APPROVED MINUTES

January 17, 2013 Standards Committee Meeting

RE: Minutes for the January 17, 2013 Standards Committee Meeting

<u>Item No. 01 12/20/12 (2012 SS)</u>	<u>Mr. Boruff (revised 01/11/13) pg 05</u>
SECTION 805	TRAFFIC SIGNALS
SECTION 922	TRAFFIC SIGNALS MATERIALS
Recurring Special Provisions:	
922-X-XXX	CONTROLLER CELLULAR MODEM
805-X-XXX	MAGNETOMETERS AND MICROLOOP DETECTORS
805-X-XXX	PREFORMED PAVE-OVER LOOPS
805-X-XXX	RADIO INTERCONNECTION
Standard Drawings:	
805-SGCF-04	SIGNAL HANDHOLE
805-SGCF-04A	SIGNAL HANDHOLE POLYMER CONCRETE TYPE
805-SCLT-01	LOOP TAGGING SYSTEM
ACTION:	WITHDRAWN

805-SGCF-04 SIGNAL HANDHOLE (REVISED DRAFT)

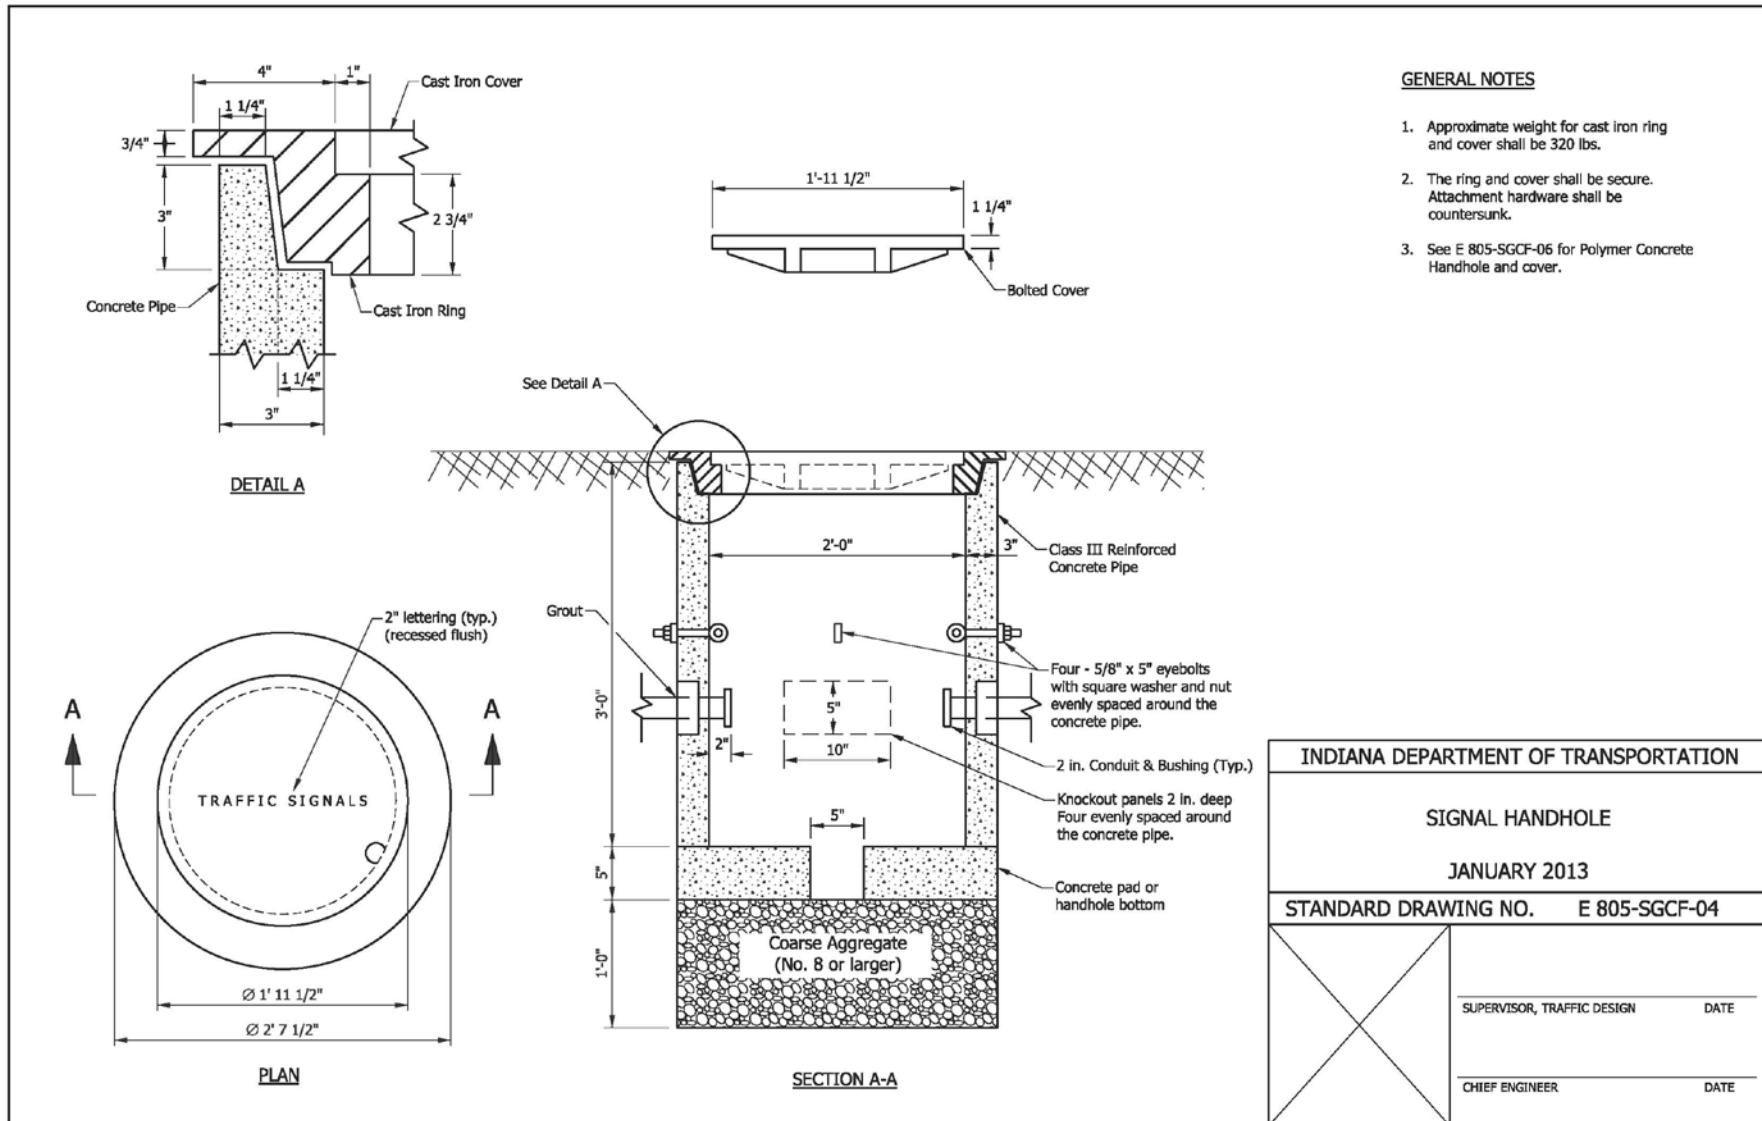
Revise Standard Drawing 805-SGCF-04 for concrete handholes and create a version for polymer concrete handholes. Delete Standard Drawing 805-SGLT-01.

EXISTING 805-SGLT-01 LOOP TAGGING SYSTEM (PROPOSED TO DELETE)

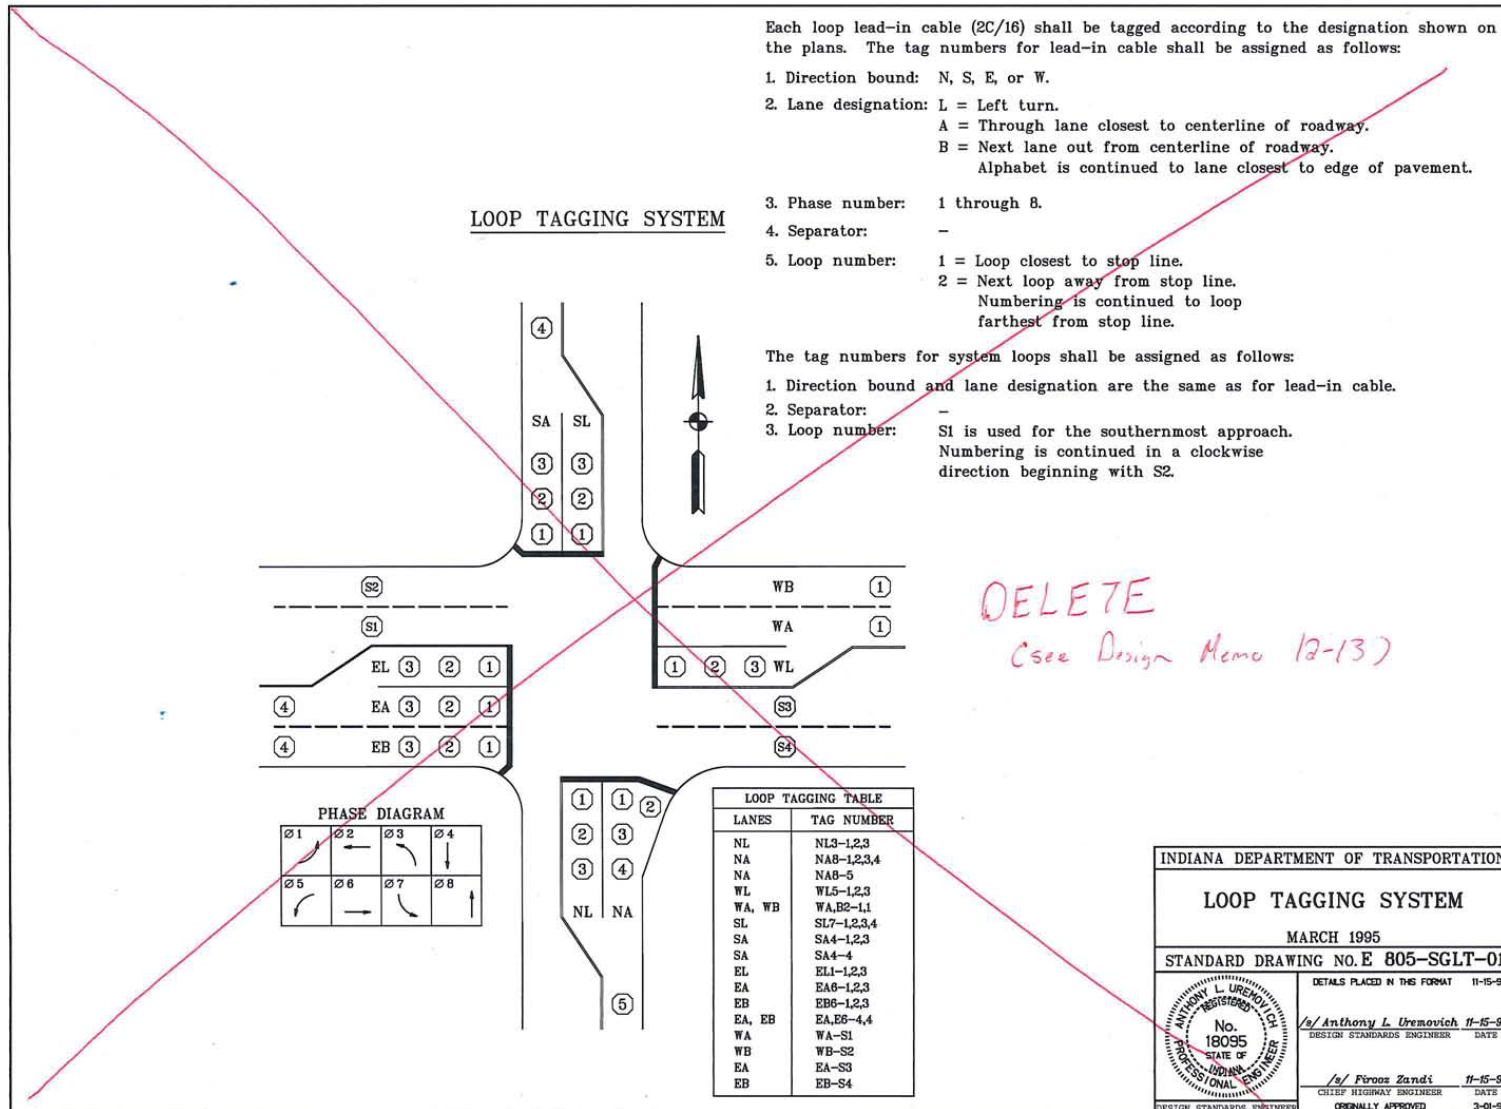
Standard Drawing 805-SGLT-01 detailing the loop tagging table is not accurate and is redundant after Design Memo 12-13.
